## Application for Works Approval

**Works Approval Number** W6855/2023/1

**Works Approval Holder** Cleanaway Solid Waste Pty Ltd

**Premises** Banksia Road Putrescible Landfill  
Banksia Road  
CROOKED BROOK WA 6236  
Legal description -  
Part of Lot 2 on Deposited Plan 65861  
As defined by the coordinates in Schedule 1 of the Works  
Approval

Figure 4: Landfill base liner configuration.

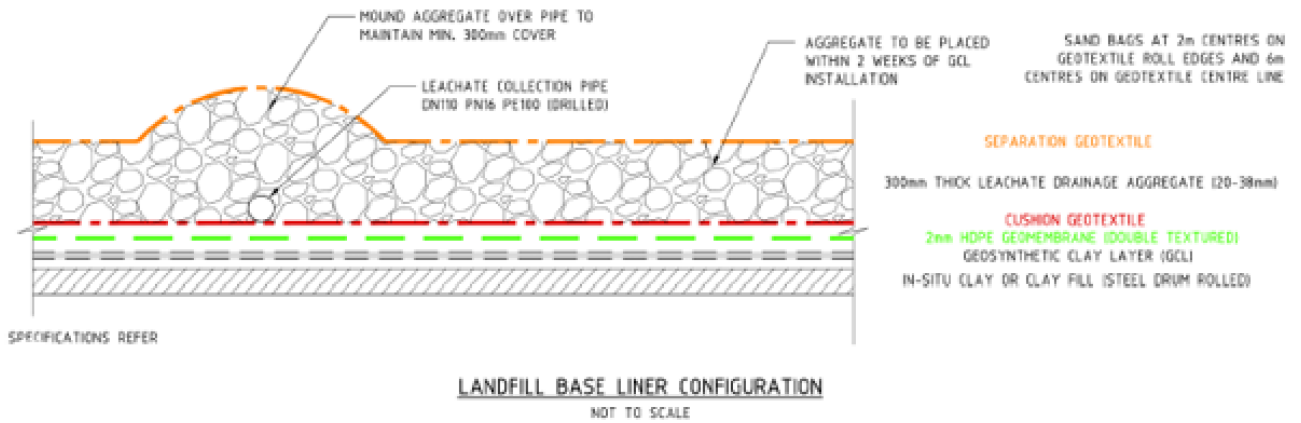
Reference	Summary of Applicant's comment	DWER response
Condition 2 Table 2, 12A Layer 7 – drainage layer	<p>This is not another layer on top of the leachate collection layer (Draft Decision Report, page 13, Table 3 refers to this as Layer 7). This is an extension of the leachate drainage layer on the side slopes which will be installed by operations progressively as the cells is filled with waste.</p> <p>Is there a need to submit a compliance document every time that operations extend the sand layer - if this is not the intent, can this condition be deleted.</p> <p>Layer also will consist of sand with a minimum thickness of 300 mm.</p>	<p>Based on receipt of this clarification that the drainage layer will be an extension to the leachate drainage layer and that it will be installed progressively during landfill operations, the Delegated Officer has removed construction requirements for the drainage layer from the works approval.</p> <p>Table 3 in the Decision Report will also be updated to reflect this.</p> <p>The installation of this layer during operations is likely to be conditioned as an operational requirement through an amendment to this works approval (for time limited operations) or through a Licence amendment.</p>

Figure 5: Landfill side slope liner configuration.

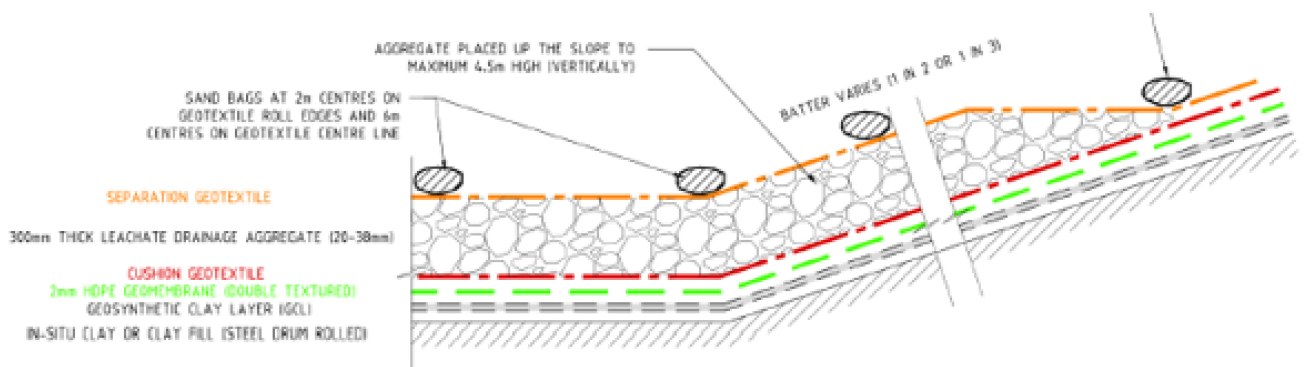
Reference	Summary of Applicant's comment	DWER response
<p>Condition 2 Table 2, Cell 9 and 10 Layer 6 – separation geotextile</p>	<p>The separation geotextile terminates on the slope, not at the top of the slope, just above where the aggregate layer terminates. The geotextile is heat-bonded to the cushion geotextile beyond the aggregate layer (refer to LANDFILL SIDE LINER CONFIGURATION on BANK-308 and BANK-408). The separation geotextile cannot be terminated in an anchor trench.</p> <p>Condition should be amended to reflect that 'geotextiles installed on the landfill side slopes must be heat bonded to the cushion geotextile beyond the aggregate layer'.</p>	<p>Condition amended as requested.</p>
<p>Condition 2 Table 2, Cell 9 and 10 Layer 7 – drainage layer</p>	<p>This is not another layer on top of the leachate collection layer (Draft Decision Report, page 13, Table 3 refers to this as Layer 7). This is an extension of the leachate drainage layer on the side slopes which will be installed by operations progressively as the cells is filled with waste.</p> <p>Is there a need to submit a compliance document every time that operations extend the sand layer - if this is not the intent, can this condition be deleted.</p> <p>Layer also will consist of sand with a minimum thickness of 300 mm.</p>	<p>Based on receipt of this clarification that the drainage layer will be an extension to the leachate drainage layer and that it will be installed progressively during landfill operations, the Delegated Officer has removed construction requirements for the drainage layer from the works approval.</p> <p>Table 3 in the Decision Report will also be updated to reflect this.</p> <p>The installation of this layer during operations is likely to be conditioned as an operational requirement through an amendment to this works approval (for time limited operations) or through a Licence amendment.</p>

**Figure 6: Cell 12A location and interaction with surrounding cells.**

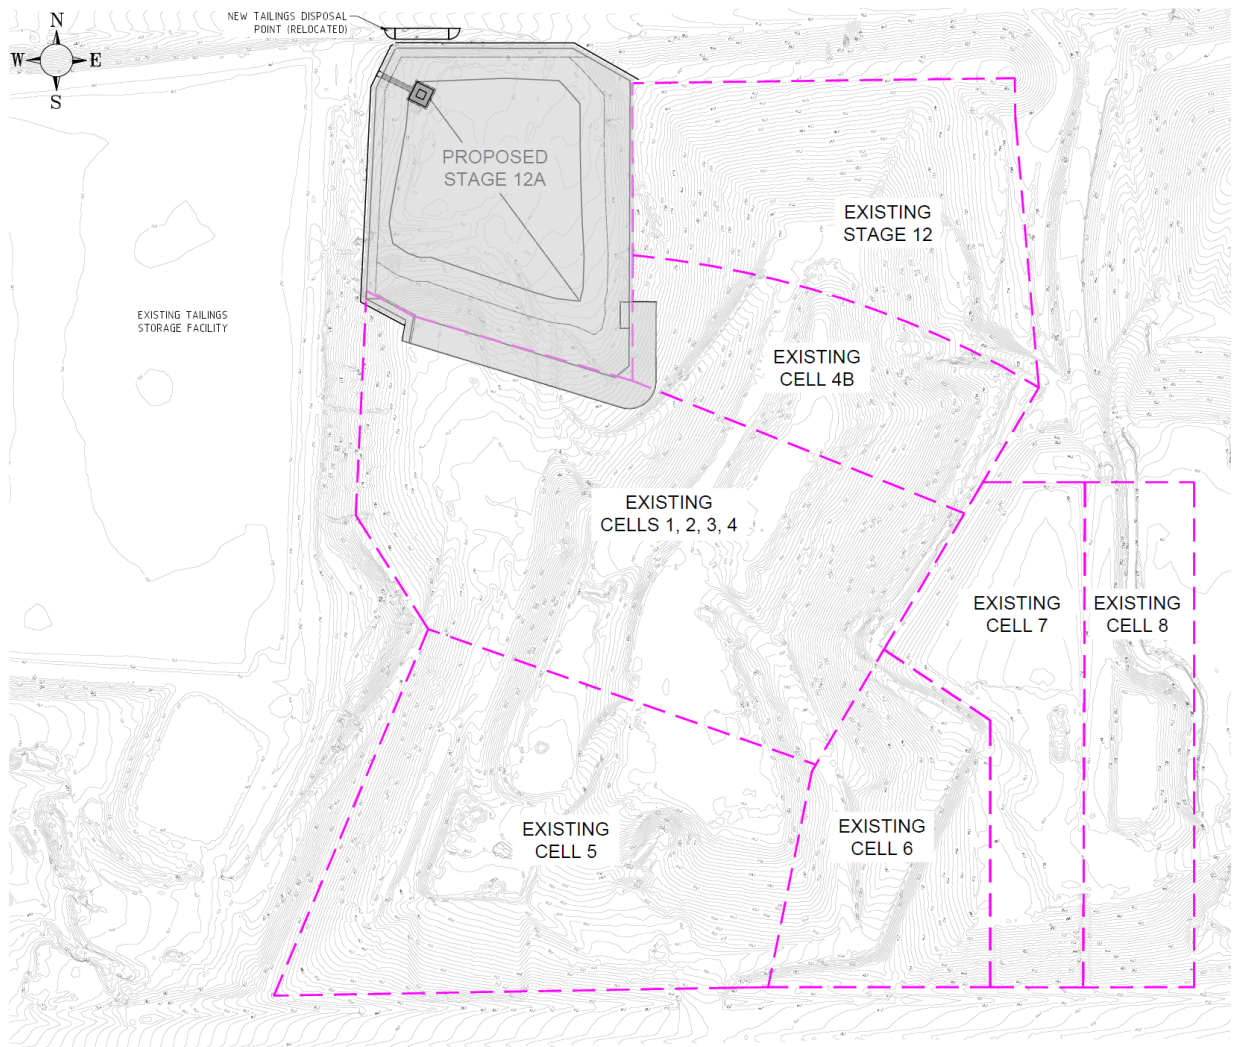
<p>There may be a risk of leachate or landfill gas migration from Cell 4B to below the Cell 12A liner.</p>	<p>Due to the Cell 4B liner dipping into the landfill and the Cell 1 and Cell 2 liners being 300 mm clay liner and in unknown location, it has not been possible to have a continuous liner tie-in to all existing cells. The piggyback liner design has been included to ensure that there is adequate environmental protection over this transition zone.</p> <p>Recently a vertical well was drilled in Cell 4B to ensure that the leachate in that cell is managed in accordance with the Leachate Plan for the site and to reduce the risk of leachate/LFG migration into Cell 12A.</p> <p>Based on the as-built information, the lowest level in Cell 4B baseliner is at RL 70.45 m, (which is over 3.5 m below the</p>	<p>The applicant has demonstrated that controls are in place within Cells 4B and 12A to mitigate the risk of leachate or landfill gas migration between the cells.</p> <p>These controls will be further considered in DWER's risk assessment relating to the construction of landfill cell 12A.</p>

<p>Cell 12A leachate sump floor at RL 74m). The recent well in 4B has been drilled to RL 71.54 m (toe of the well). With the proposed pump, the leachate level can be drawn down to RL 72.4 m which meets the requirements of the Leachate Plan.</p> <p>The site has an existing extensive landfill gas extraction system within the waste mass, including in Cells 1, 2, 4, and 12 surrounding Cell 12A. Landfill gas is currently adequately being extracted from the landfill. This situation will continue as Cell 12A is filled with waste. With the active extraction of gas from around the liner tie-in area, there will be adequate control of landfill gas to prevent or significantly reduce any fugitive emissions from escaping below the new Cell 12A liner. In addition, the natural soil below the new liner consists of the typical in-situ silty clay that has a low permeability and hence, will resist the percolation/lateral movement of landfill gas out of the landfill.</p>
